Applicant : Jordan T. Bourilkov et al.  
Serial No. : 10/616,495  
Filed : July 9, 2003  
Page : 12 of 17

Attorney's Docket No.: 08935-292001 / M-5028

REMARKS

FIG. 3A

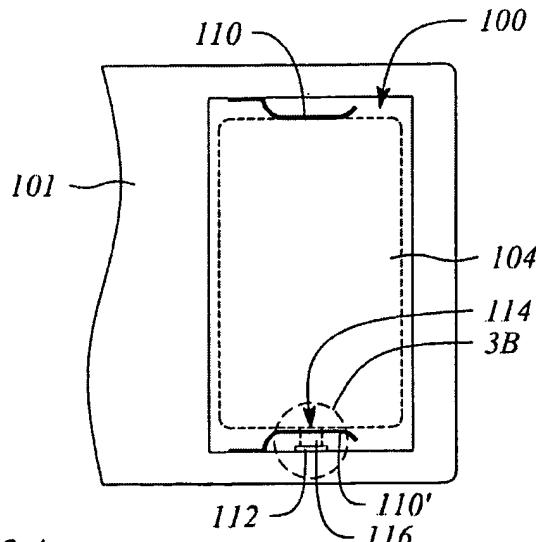
Bean et al. in Figures 2 and 3 A disclose mating fitting on a member that a pair of spaced battery terminals and an aperture to receive an ingress port on a fuel cell interconnect.

Therefore, it would have been obvious to one of ordinary skill in the art at the time the invention was made to have modified the member and interface of Sainsbury et al. by incorporating the mating fittings of Bean et al. because Bean et al. disclose mating fittings that would have provided a portable electronic device with a power supply that may be interchangeably energized using energy stored in a battery or energy derived from the operation of a fuel cell, enabled the user of the device to flexibly determine during device use whether to employ the battery or the fuel cell as a power source, users of the device from having to provide for a particular one of a fuel cell cartridge or a battery when a currently installed battery or fuel cartridge becomes depleted thereby improving overall performance, efficiency and operations.

Applicant contends that the combination of Bean with Sainsbury fails to suggest the features of claim 2. Bean does not teach “the mating fittings on the member include a pair of spaced battery terminals and an aperture to receive an ingress port on a fuel cell interconnect,” as the examiner argues. Rather, Bean discloses the arrangement shown in FIG. 3A reproduced below:

In this arrangement, the compartment interchangeably holds either a battery or a fuel cartridge. However, Bean has only contemplated a compartment to receive conventional cells in which anode and cathode are on opposite ends of the battery. In contrast, Applicant's mating

fittings on the member include a pair of spaced battery terminals and an aperture to receive an ingress port on a fuel cell interconnect. No such member is disclosed by Bean.

Moreover the motivation to combine Bean with Sainsbury is inadequate because Sainsbury is not directed to an arrangement involving the source of fuel for a fuel cell. Therefore any combination of Sainsbury with Bean would have modified Sainsbury in a manner that destroyed to intent, purpose or principal of operation of Sainsbury and is *per se* not suggested. Accordingly, the claims are allowable over the art.
